February 28, 2018

SCO ID No. 16-12916-01A

ADDENDUM No. 2

NCDOT LUMBERTON EQUIPMENT SHOP Lumberton, NC

ATLANTA • CHARLOTTE • GREENVILLE • RICHMOND 877.4.DEVITA • corp@devitainc.com DeVita & Associates, Inc. Project : 17500-00 NC Firm License # C-0819	DATE: 02/27/18 DRAWN BY: DRB CHECKED BY: MCH	REVISION:  ADDENDUM 2	
	SCO#: 16-12916-01A	REFERENCE DWG: E0.3	DWG: BD-2

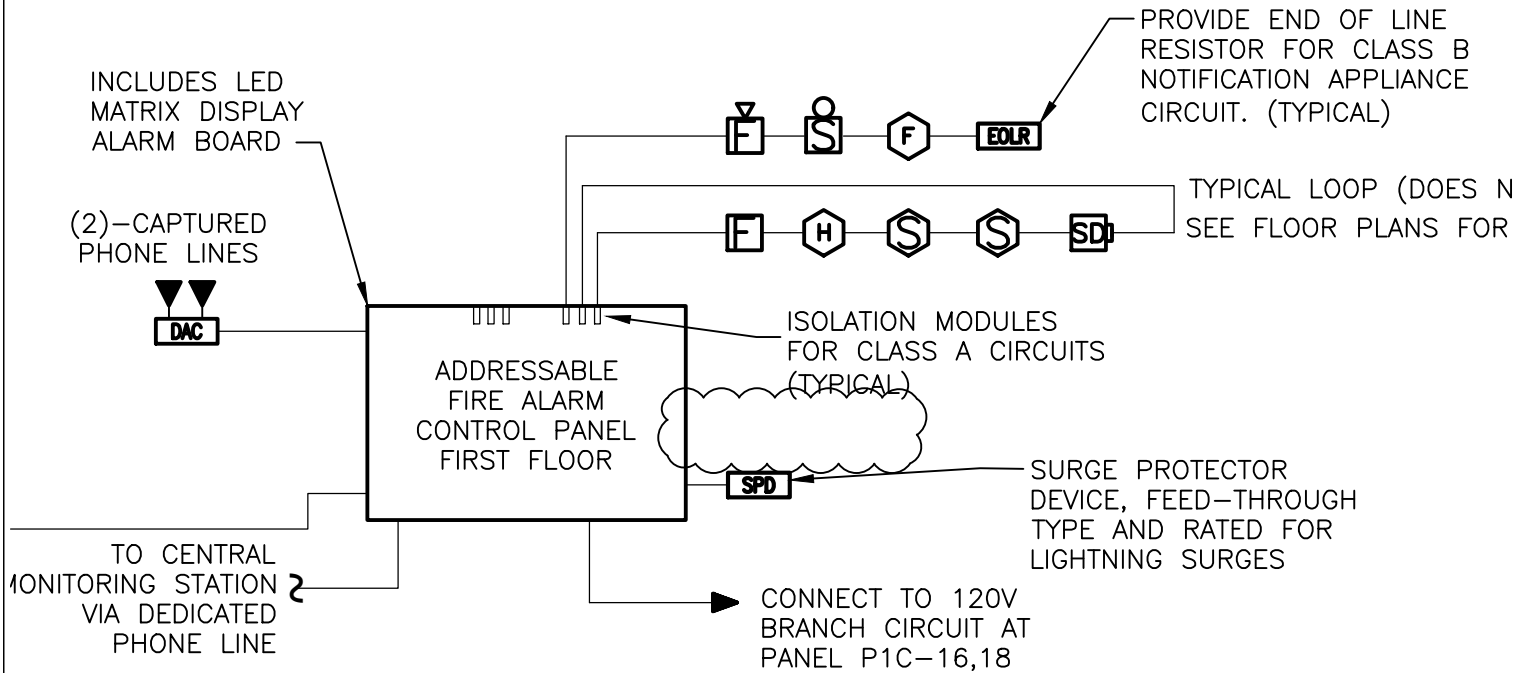
9. Drawing E0.3 Refer to Drawing E0.3 “Electrical Site Plan”. Provide (4)-2C from Manual Transfer Switch to CB per Bulletin Drawing BD-2 (Attachment ‘A’).
